INDESIT company

MBZE45NFBART

F034156

RE0259T0 Exploded views

RE0261T0 Exploded views

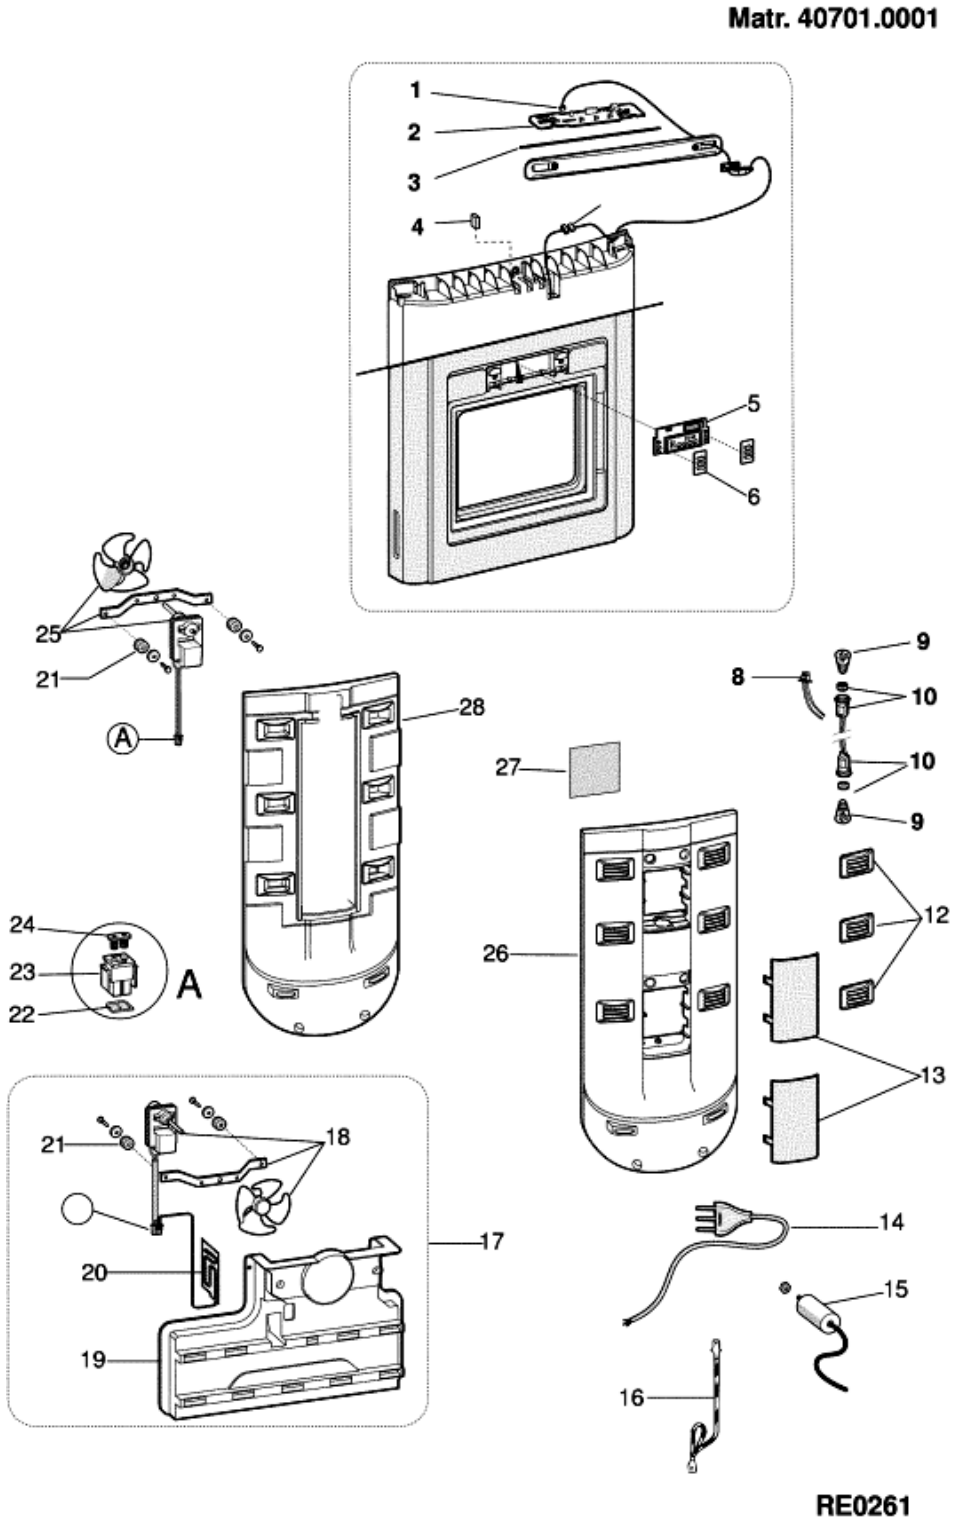
0999375: multiflow rezistance usage

Since 30/09/2005 multiflow rezistance will be used on MBZE 45 NF BAR T model due to this reason wiring assembley will be changed. You can find new part codes below:

new parts;
112462- multiflow rezistance
141523- wiring assembley for lamp

0999379: TWO HOLES HAVE BEEN CANCELLED ON MULTIFLOW FOR COMBIES

Due to low temperature at the lower part of the fridge section on Manisa combies two holes which are placed on multiflow cover have been cancelled for all combies since 13/04/2006.

RE0262T0 Exploded views

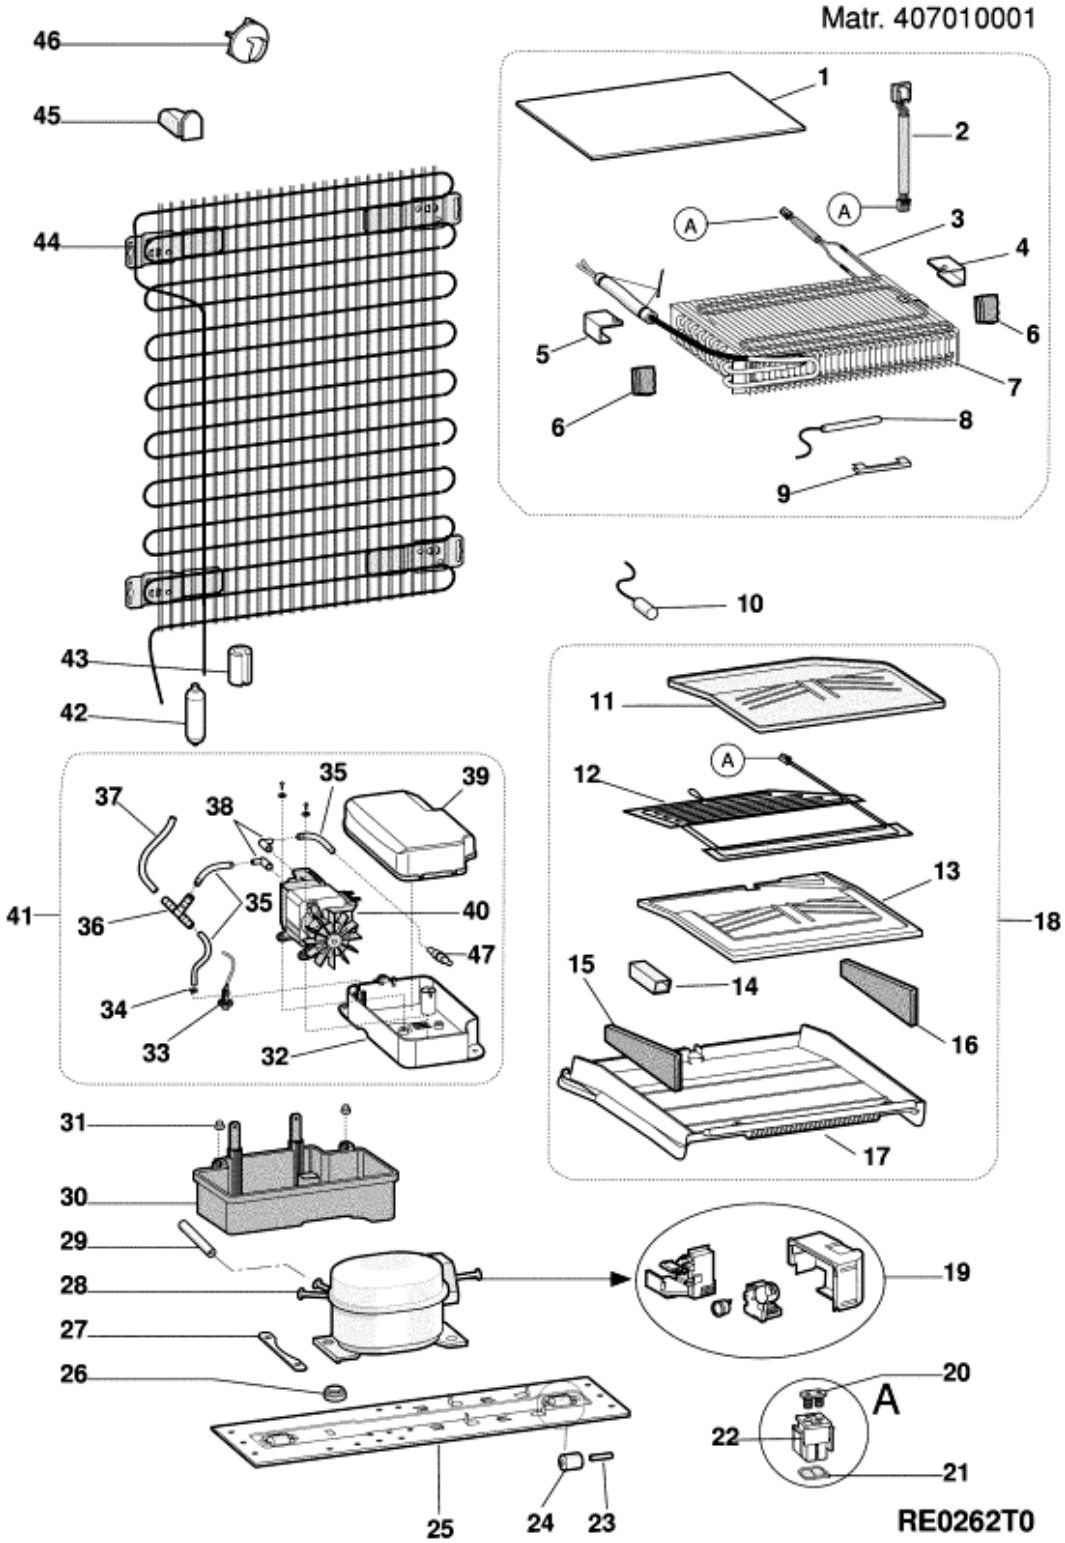
0999376: ICE FORMATION AT THE BACK OF THE EVAPORATOR

Below modifications have been performed to prevent ice formation at the back of the evaporator on L70 combies. These new parts can be supplied as an assembly C00141277
1- Spugnetta evaporatore left and right have been modified since 12/08/2005. Spare part codes remain the same (C00094468-C00094467). These parts must be replaced together in case of necessity of the replacement.

2- Power of the rezistance for divisorio camere has been increased from 40W to 50W since 03/10/2005. Spare part code remains the same (C00095774).

3- Power of the rezistance for evaporator has been increased from 140W to 150W since 26/09/2005. Spare part code remains the same (C00115199).

4- Drain hose end piece C00141278 has been used for draining the water to the evaporating tray since 26/09/2005.

5- Fan motor plastic assembly has been modified. The hole for propeller has been modified to prevent friction between propeller and fan motor plastic since 03/10/05.
Spare part code remains the same (C00116498).

These new parts can be supplied as an assembly C00141277.(TB001014 - ex.TECHNICAL NEWS STN-CL 0511.1)
